**COMMENTS ON CONTEMPORARY WORDING OF REGULATION No. 17-07**  
(APPROVAL OF VEHICLES WITH REGARD TO THE PROTECTION OF THE SEATS, THEIR ANCHORAGES AND HEAD RESTRAINTS)

**Transmitted by the Expert from Czech Republic**

E/ECE/324  
E/ECE/TRANS/505/Rev.1/Add.24/Rev.1  
Regulation No. 25 - 03  
Page 33  
Annex 5

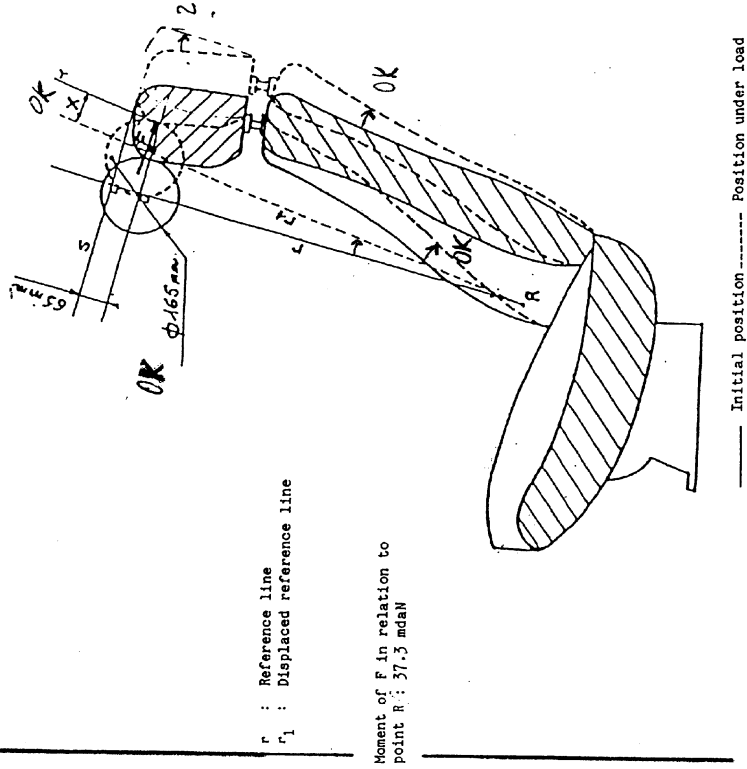
Justification: From the four drawings presenting the same problem of „Details of lines drawn and measurements taken during tests“ which were officially published in Annex 5 to **ECE 17R-04** (with mistakes a,b), in Annex 5 to **ECE 25R-03** (with mistake b), in Fig.2 of App.3 of Annex II to **96/37/EC** (with mistakes a,b, c!) and in **Annex IV to 78/932/EEC** (no mistake) the only last one mentioned here is perfectly correct, see enclosures 1,2. The use of the last Figure like the most simple and illuminating one also for all other cases mentioned could emphasize the desirable EC to ECE harmonization.

E/ECE/324  
E/ECE/TRANS/505/Rev.1/Add.16/Rev.3  
Regulation No. 17-04  
Page 43/44  
Annex 5

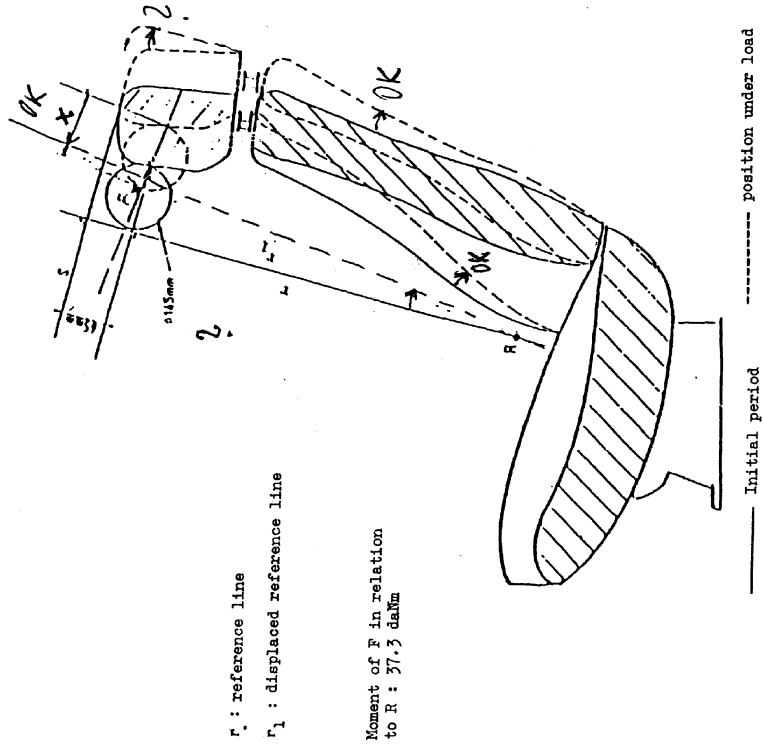
Annex 5, amend the drawing to bring it into compliance with the relevant description in text emphasizing the three main conditions as follows:

- a) the **radius of the sphere**  $165/2=82,5$  mm shall be diagrammed greater than the distance 65 mm,
- b) the **displaced position of head restraint** under loading force **F** shall be given by its rotation around the point **R**,
- c) the **measured deformation „x“** shall be given by the distance of two parallel lines: the displaced reference line **r<sub>1</sub>** and the tangent **Y** in contact „sphere-restraint“.
